Final Report - Corrections Required **Application No. DEPN-26-0068**

Description : single family residential development with optional ADU. 41 lots

Document Filename : DP Creekridge at Flying Horse Filing No 2.pdf

CREEKRDGE AT FLYING HORSE FILING NO. 2 DEVELOPMENT PLAN SITE DEVELOPMENT PLAN			
DESIGNED BY	JRH	SCALE	DATE 5/13/26
DRAWN BY	JRH	(H) 1" = 40'	SHEET 2 OF 14
CHECKED BY	(V) 1" = N/A	JOB NO.	1171.79

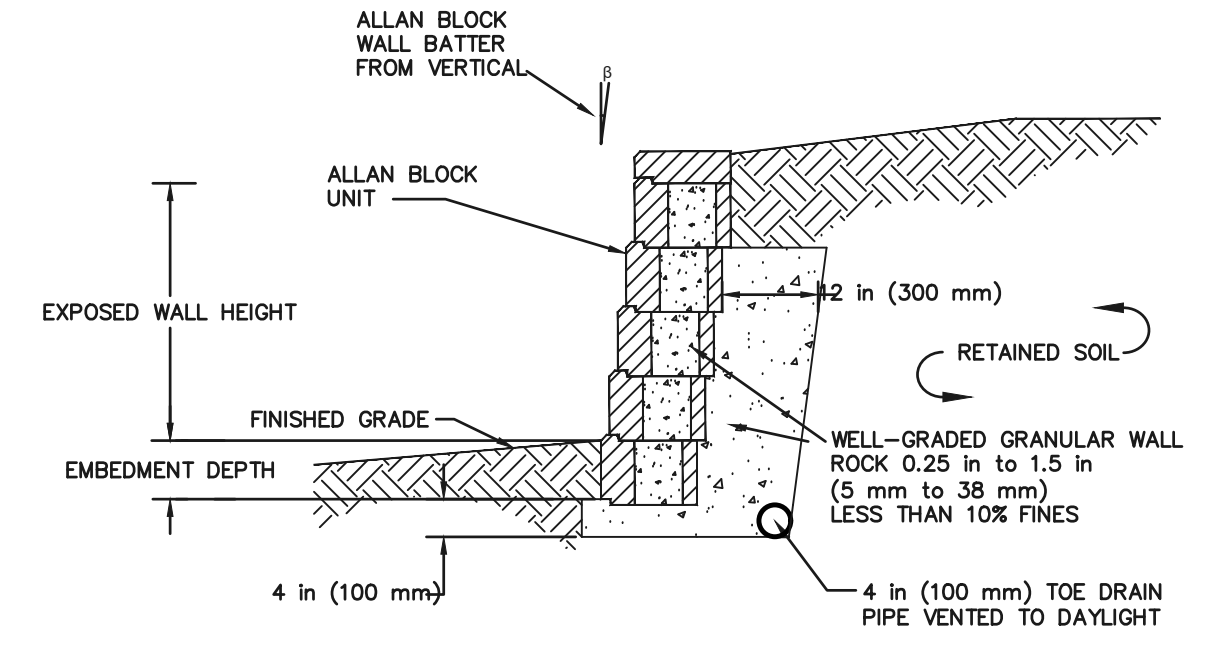
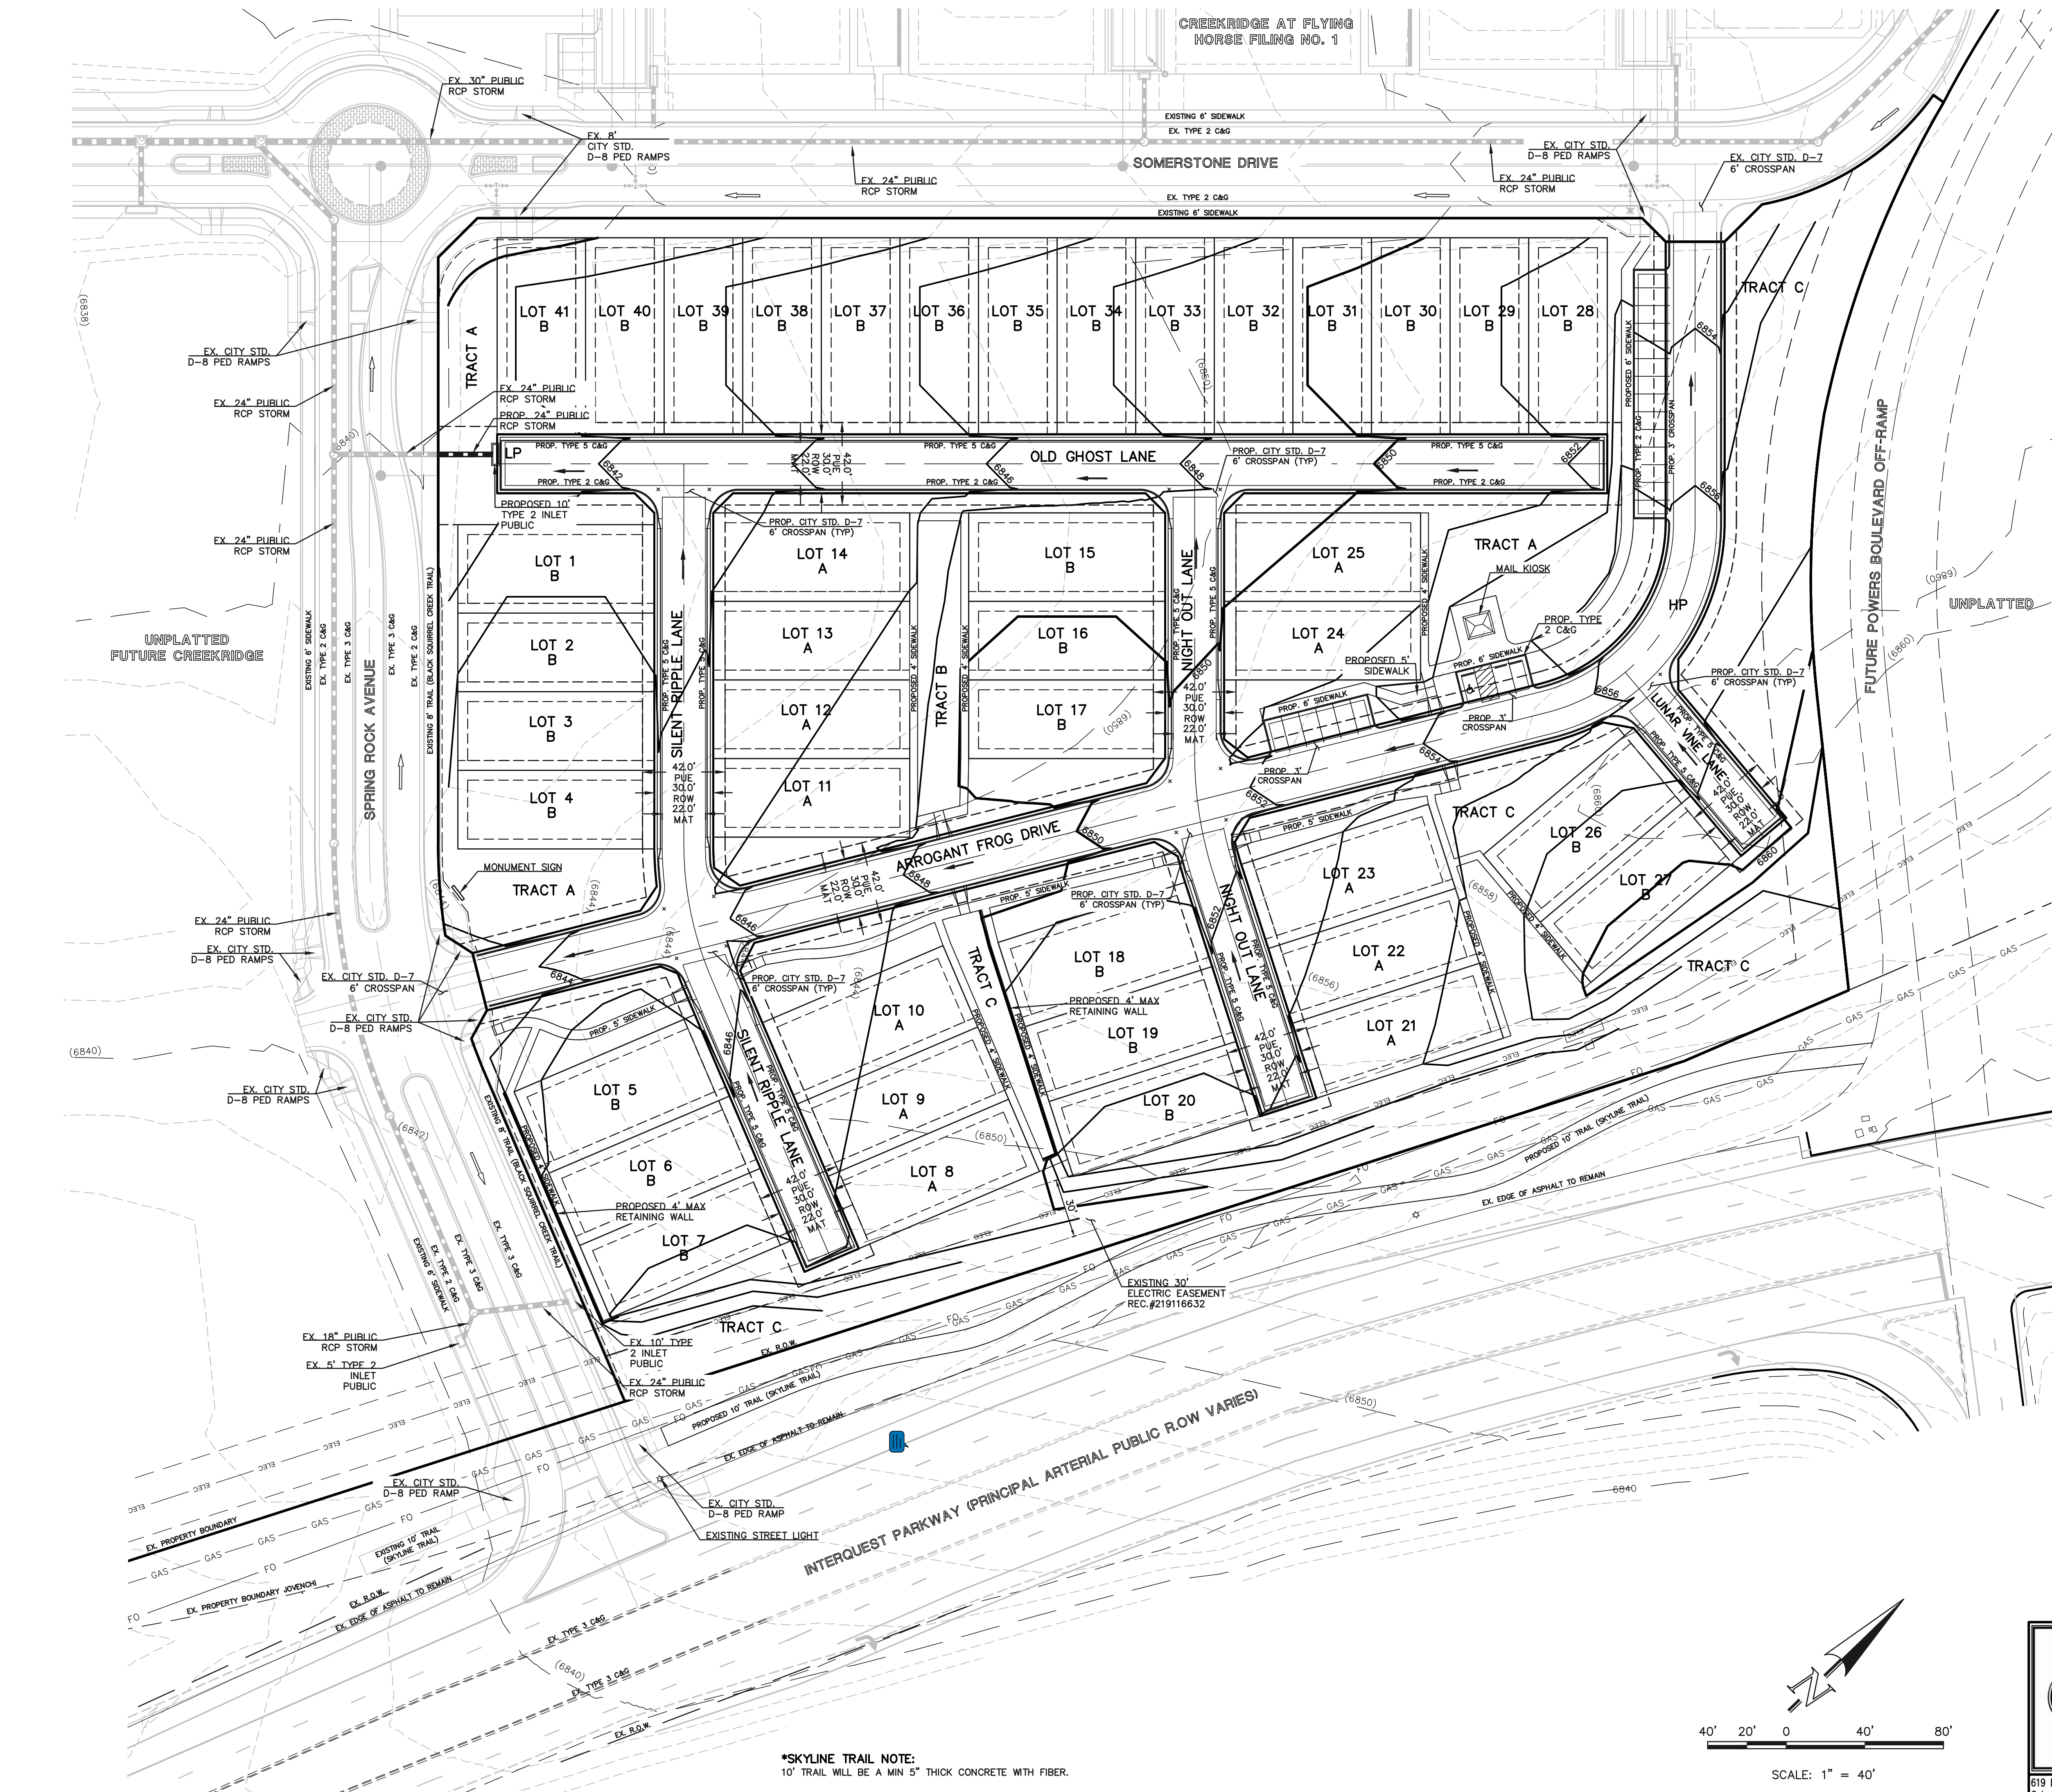
Show gas main in center
per GLESS A3-14 detail.

Similar to Filing No 1, please
make sure adequate sidewalk
connections are being made
along the roadways

note that corner side
yard setbacks are 15ft

Please include front
yard setbacks

Consider sidewalk
connection here

Will there be a sidewalk
along the southerly
portion of Somerstone Dr
connecting to Filing No 1

Provide a note or other
explanation on what a "use
easement" is

Consider connections
from internal sidewalks to
the Skyline Trail
